Access Compliance Report

Public Rights-of-Way

(Curb Ramps)

Intersection ID: 49130	Main Street: AUBURN_HILL_LN	Cross Street: WILTSHIRE_RIDGE_RD	Location: NE
ADA ID: F88FE92D558E	Ramp Type: Perp	Initial Pass/Fail: Fail	Overall Compliance: No
Severity Score: 10			
Codes/Mitigation Info/Possible Solution		Field Measurements/Component Compliance

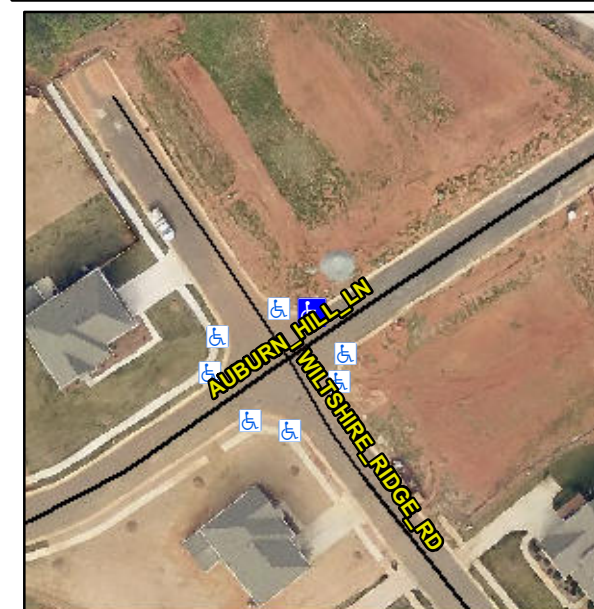
Not Found, R304.5.1

Compliance	Description	Data	Compliance	Description	Data
N/A	Ramp Length (in)	49.0	Yes	Ramp Slope (%)	5.2
No	Ramp Width (in)	47.0	Yes	Ramp XSlope (%)	2.9
N/A	Flare Type LT	N/A	N/A	Flare Type RT	N/A
N/A	Flare Slope LT (%)	N/A	N/A	Flare Slope RT (%)	N/A
N/A	Flare Traversable LT?	N/A	N/A	Flare Traversable RT?	N/A
N/A	Landing Length (in)	N/A	N/A	DWS Provided?	N/A
N/A	Landing Width (in)	N/A	N/A	DWS Contrast?	N/A
N/A	Landing Slope (%)	N/A	N/A	DWS Length (in)	N/A
N/A	Landing X Slope (%)	N/A	N/A	DWS Full Width?	N/A
N/A	Landing Curb? (Y/N)	N/A	N/A	DWS Offset (in)	N/A
N/A	Shared Landing?	N/A			
N/A	Gutter Ponding?	N/A	N/A	Gutter Slope (%)	N/A
N/A	Gutter Lip Ht (in)	N/A	N/A	Gutter X Slope (%)	N/A
N/A	Painted X Walk1?	No	N/A	Painted X Walk2?	N/A
	X Walk 1 Direction	To S		X Walk 2 Direction	N/A
N/A	X Walk 1 Width (in)	N/A	N/A	X Walk 2 Width (in)	N/A
	X Walk 1 Slope (%)	0.1		X Walk 2 Slope (%)	N/A
	X Walk 1 X Slope (%)	4.0		X Walk 2 X Slope (%)	N/A

Remove & Replace Entire Ramp.
